REVIEW OF REPORTS BY GIBBS AND COX, INC., LOCKHEED MISSILE  
AND SPACE CORPORATION, M. ROSENBLATT AND SONS,  
ON 400 MWe COMMERCIAL OTEC PLANTS

Final Report

June 1979

JOHN J. McMULLEN ASSOCIATES, INC.  
One World Trade Center - Suite 3047  
New York, New York 10048

FIGURE 2.2.1

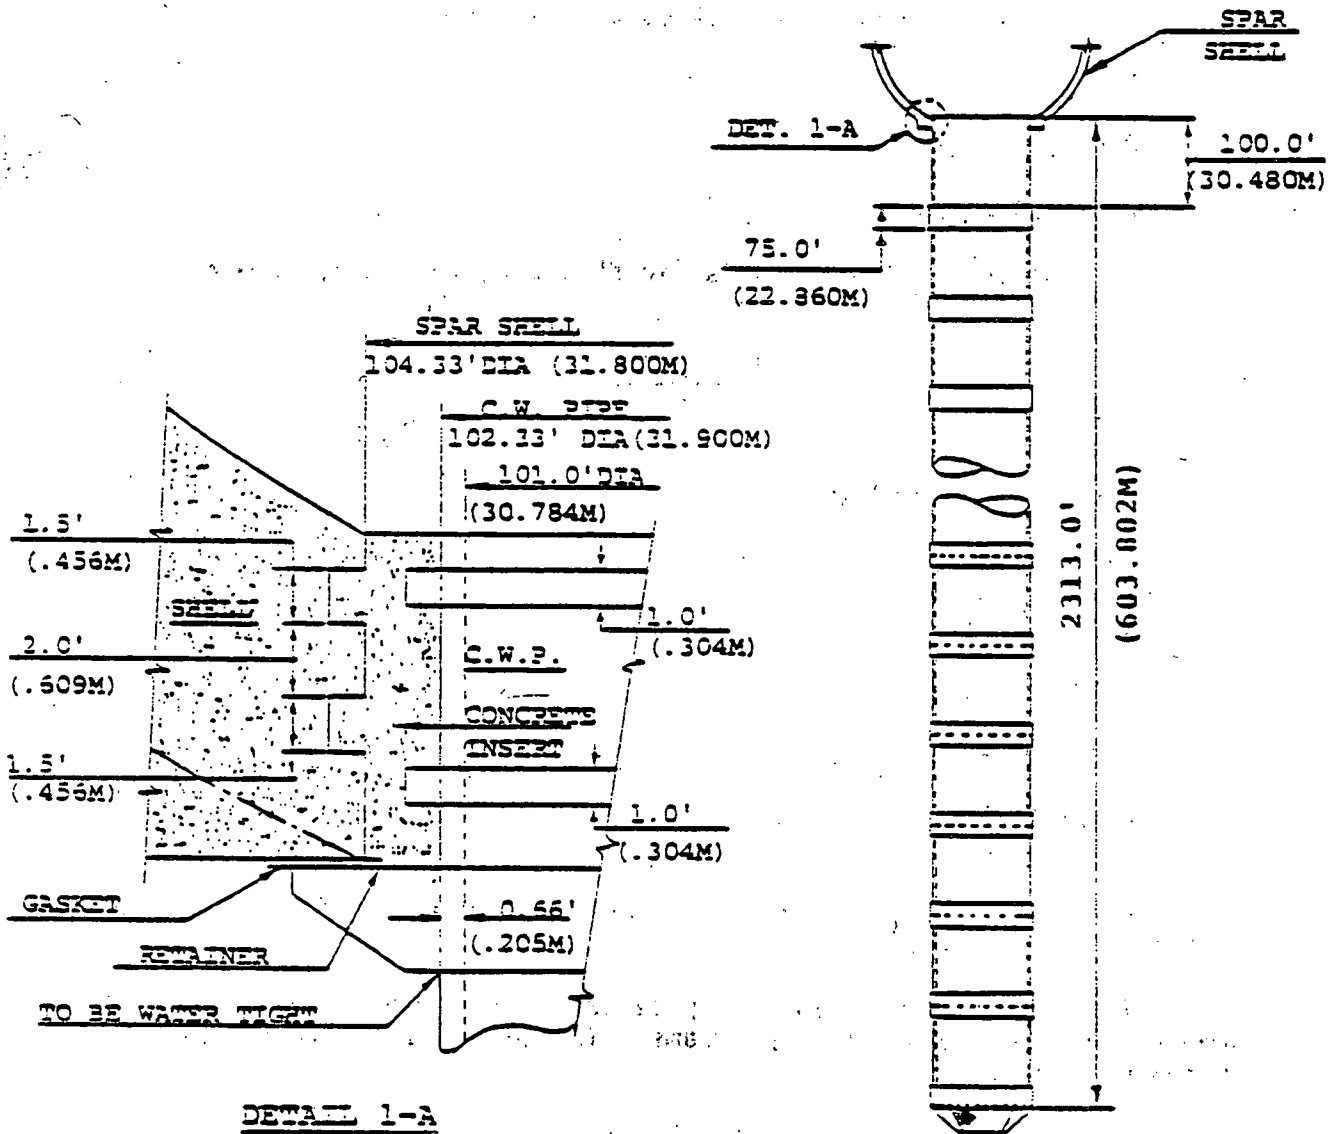
MR&S material selection is largely a consequence of their decision to use rigid connections only. This conclusion was reached on the grounds that flexible connections would be prohibitive in cost. It is not supported by the results presented by G&C and by Lockheed and on the basis of data presented for the Commercial OTEC Plant, it appears to have resulted in an unduly expensive solution. More recent data on GRP with reduced pipe thickness seem however, to show GRP in a more favorable light.

Figure 2.3.3

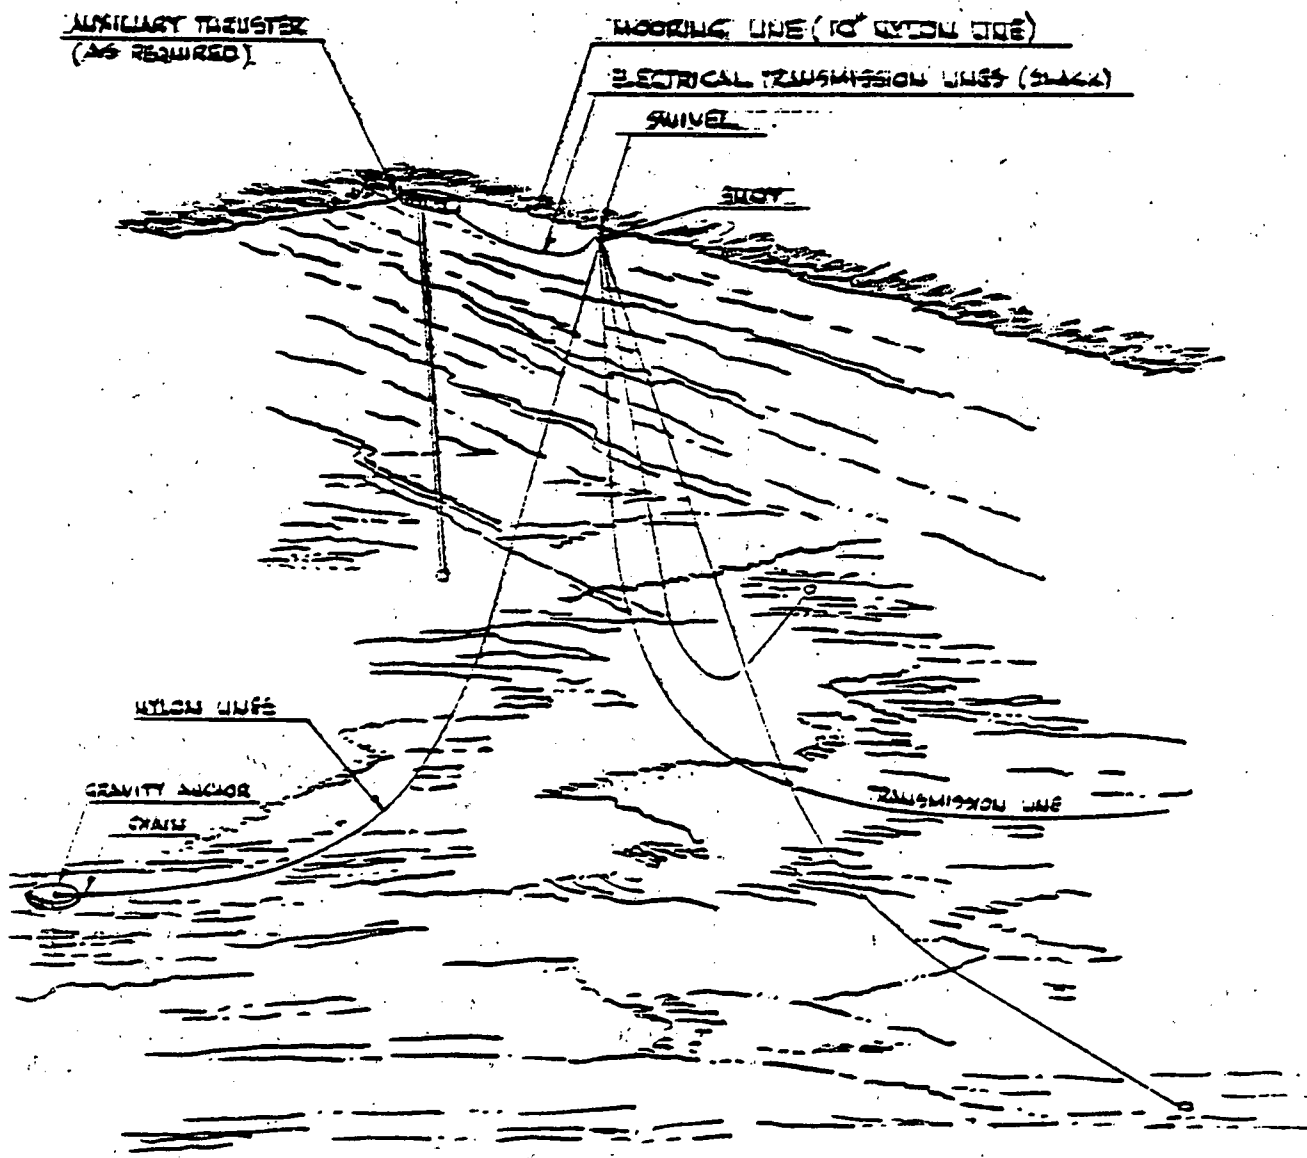
LMSC postulates a weathervaning capability to limit loads and in order to provide this capability they moor the platform by lines to a buoy. There are a number of disadvantages inherent in this approach. Under certain circumstances the cold water pipe may foul the mooring cables. A swivel connection is required at the buoy for the transmission lines. This is a large and costly fitting and is believed to be beyond the present state of the art. Auxiliary power thruster may be required to assist in directional control, in keeping the mooring line tight and in avoiding drift of the ship on the buoy. This increases first costs and decreases the reliability of the system. Elimination of the weathervaning capability would on the other hand, increase the mooring loads by an order of magnitude of 250%.

Figure 2.3.4

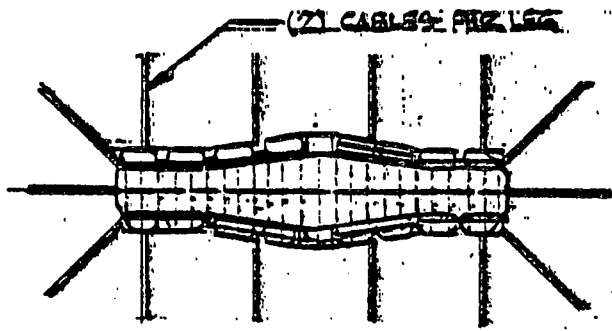
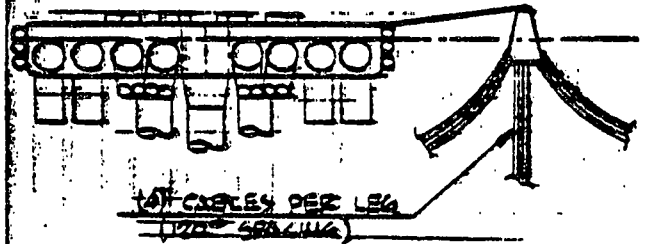
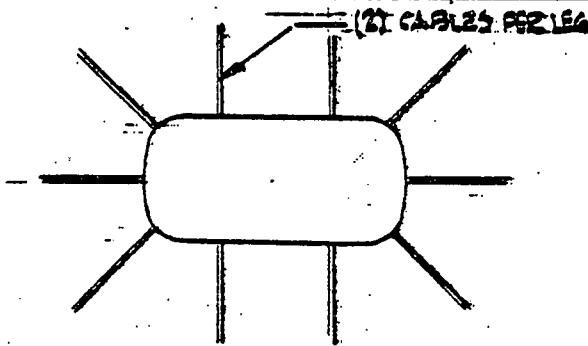
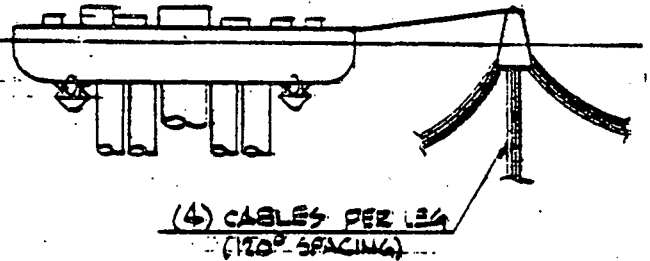
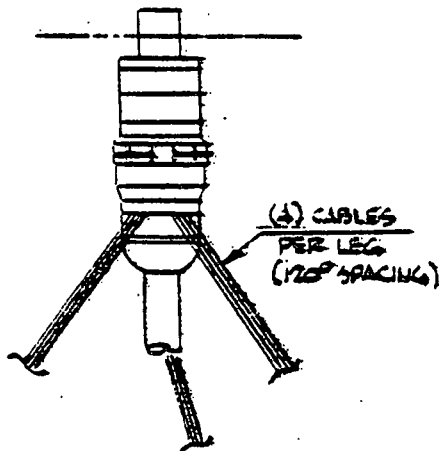
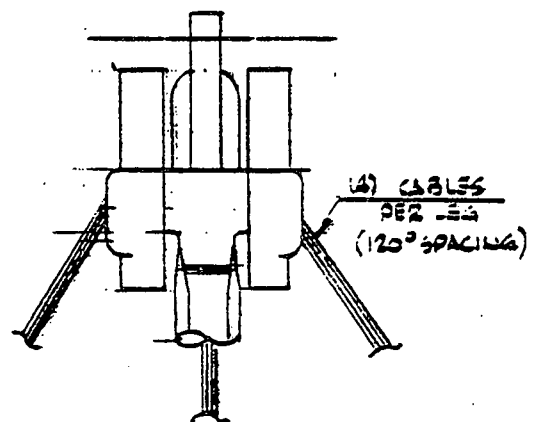
Figure 2.3.4 illustrates the proposed concepts. Their characteristics are given in Table 2.3.3.

FIGURE 2.5.1

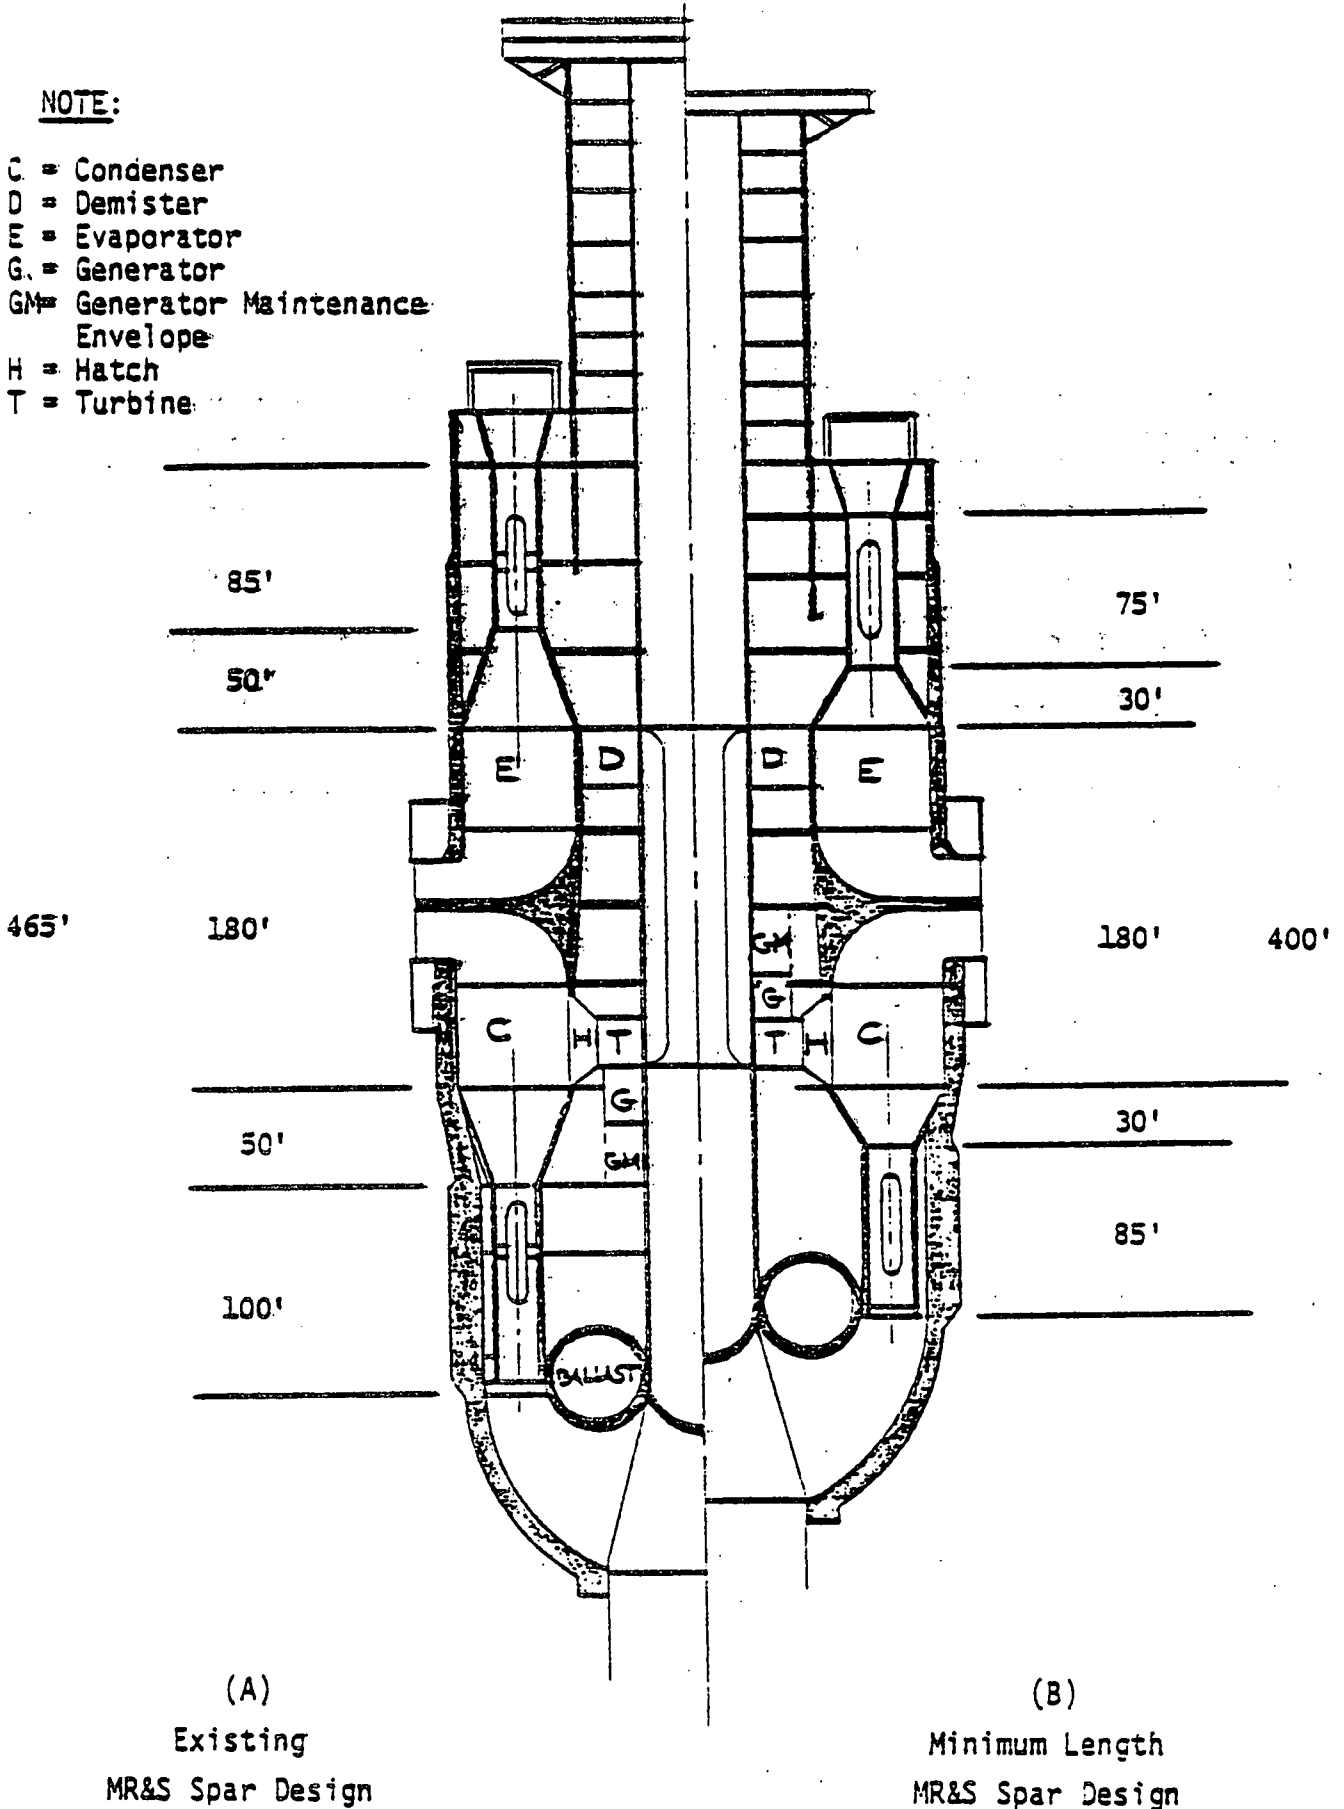
The MR&S spar platform sea water systems design was reviewed. It was determined that the warm water piping could be reduced approximately 9 percent (30 feet) and the cold water piping could be reduced approximately 15 percent (35 feet) as shown on Figure 2.5.1. The system components shortened and the amounts are shown in Table 2.5.1. The warm and cold water discharge elbows were not modified since the present design appears to be as compact as practicable.

The MR&S spar platform arrangements were then reviewed in more detail to determine if this degree of reduction was practicable from an arrangements standpoint. Present arrangement of the spar in the cold water area (elevations 250 ft. through 590 ft.) is quite saturated with equipment. However, relocating the generators to a position above the turbine would provide adequate room. With the reduction of the cold water pump diffuser by 20 ft. the distance between the generators and the power conditioning equipment and switchgear would not be significantly increased. The cold water pump tailpipe shortening could be accomplished by reducing the deck height in the ammonia storage area and by relocating the ballast torus downward. Considerable unassigned space exists in the warm water area (Elevations 100 ft. through 350 ft.) and achievement of 30 ft. reduction is possible with minimum modification.

FIGURE 2.5.2  
PLATFORM NET POWER VS.  $\Delta L$

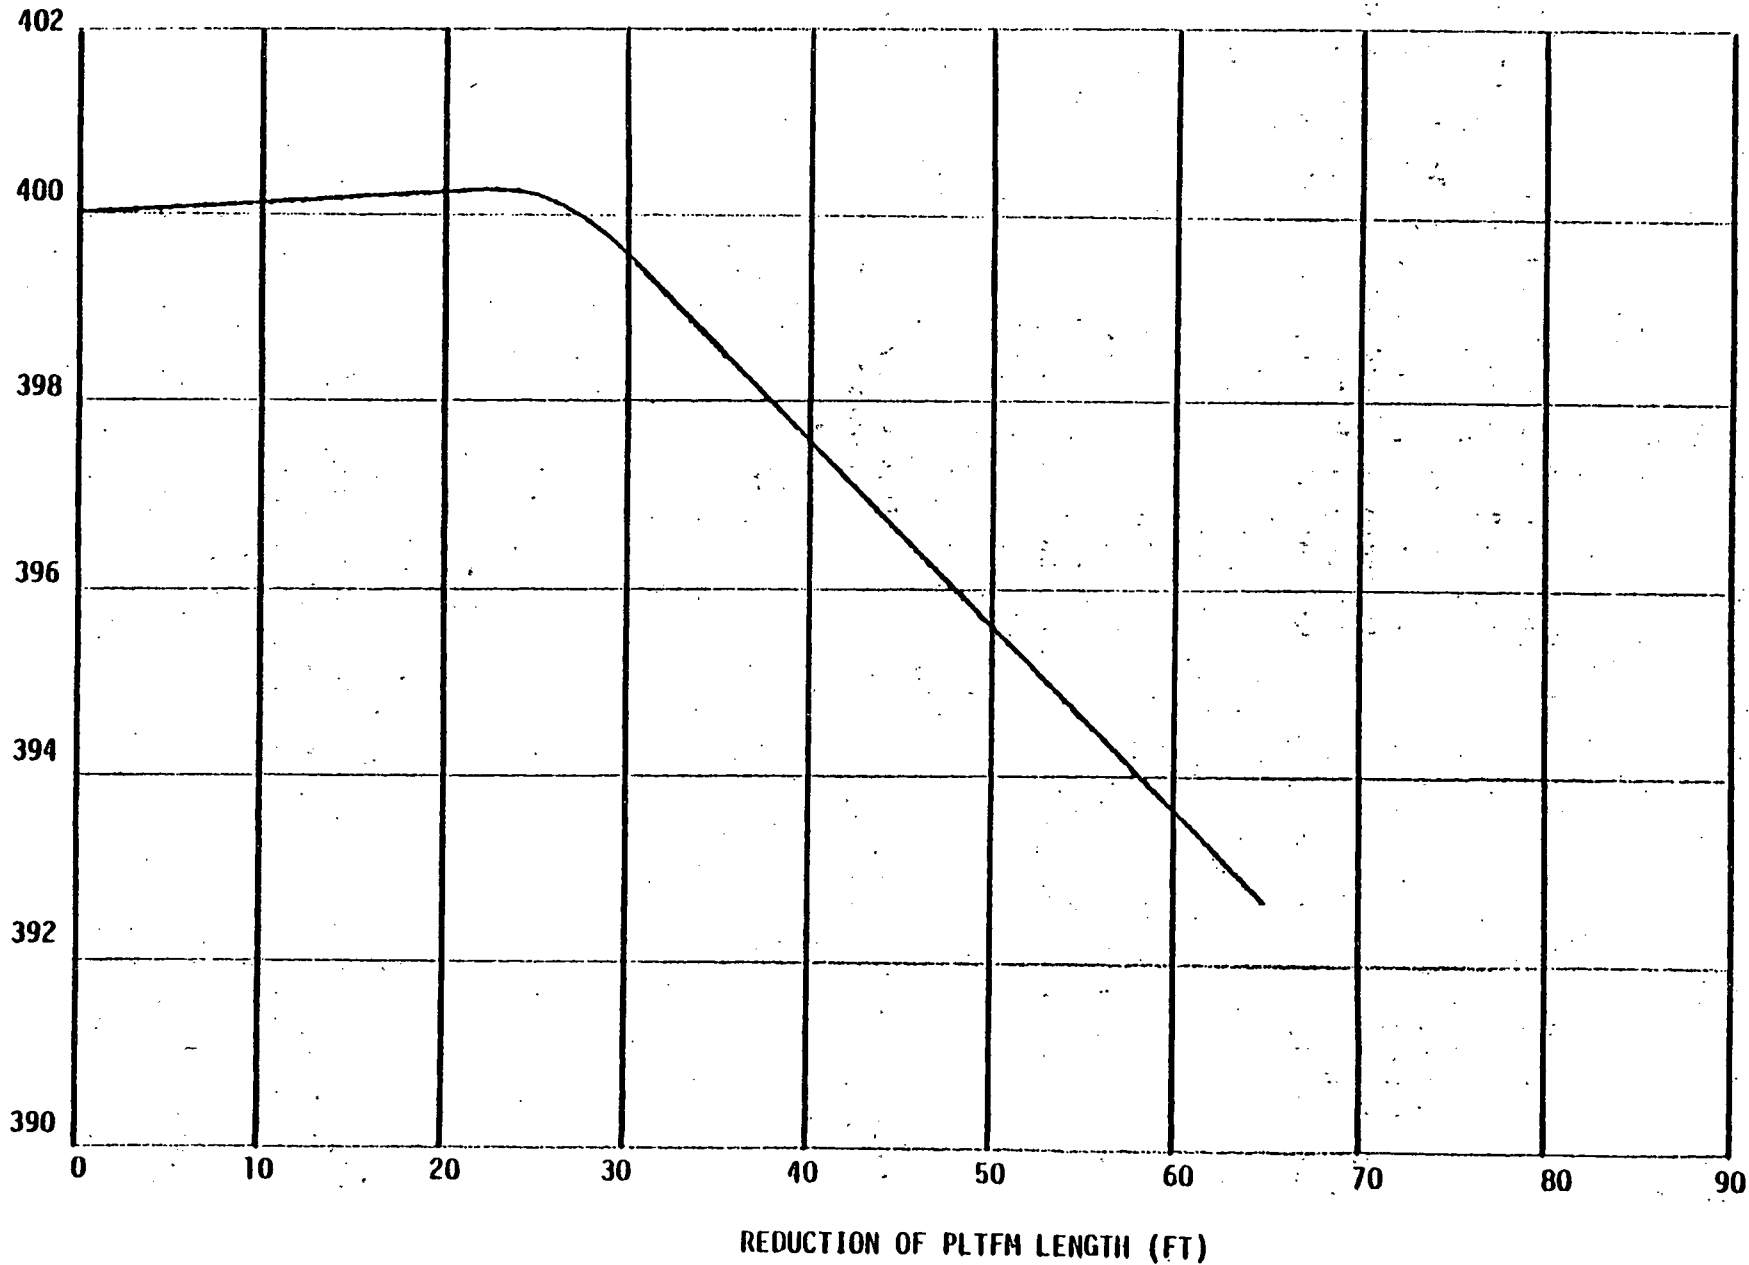
A life cycle cost analysis was carried based on the MR&S life cycle costs estimates summarized in Table 52 of Reference 1. Changes in net power output were plotted against reductions in length and are shown in Figure 2.5.2. Cost savings were calculated for length reductions of 20, 40 and 65 feet. The resultant life cycle costs per megawatts are shown in Table 2.5.5 for length reductions up to 65 ft. Optimum life cycle costs occur at a reduction of approximately 20 ft.

Figure 2.6.4

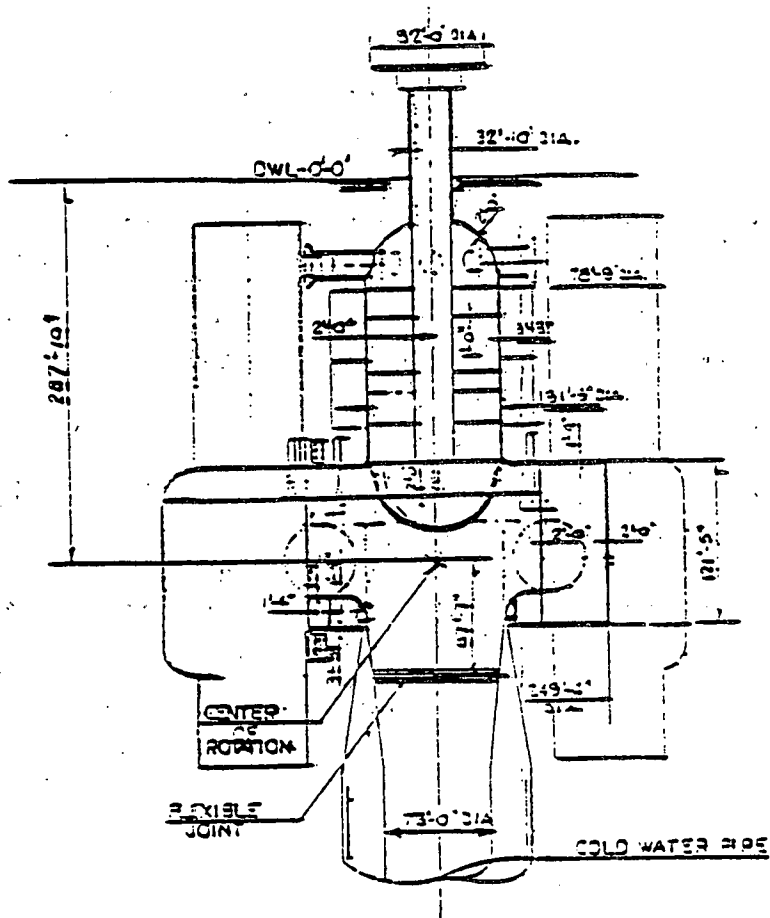
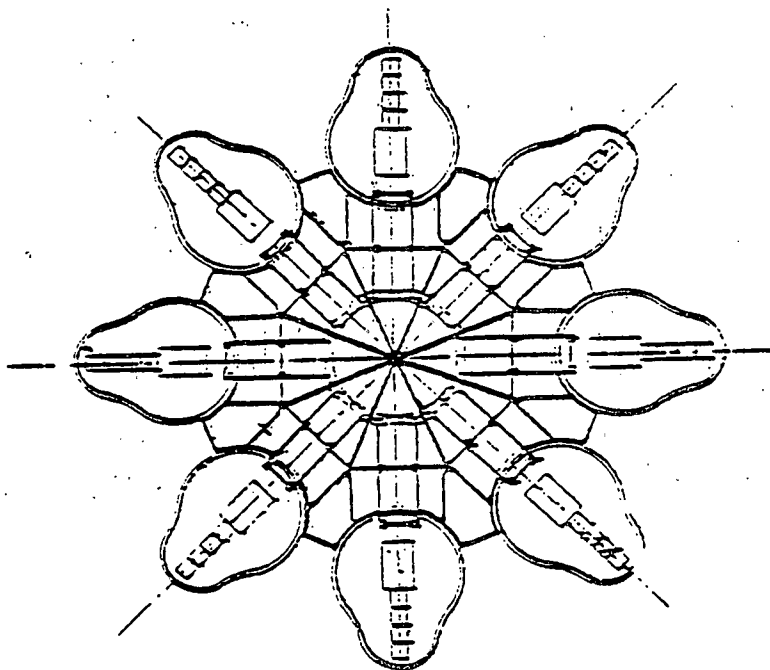
A check was made by JJMA of the strength modulus in the areas where bottom openings provide the greatest potential for structural discontinuities. This showed the structure to be adequate.

The calculations for the LMSC spar structure, in the Appendix to Reference 3 show that the scantlings of the core are based on an average draft of 45m. This draft is based on a distance of 10 meters (33 ft.) from the hot water inlet opening to the surface of the water which appears inadequate. A minimum submergence for the hot water inlet is as follows:
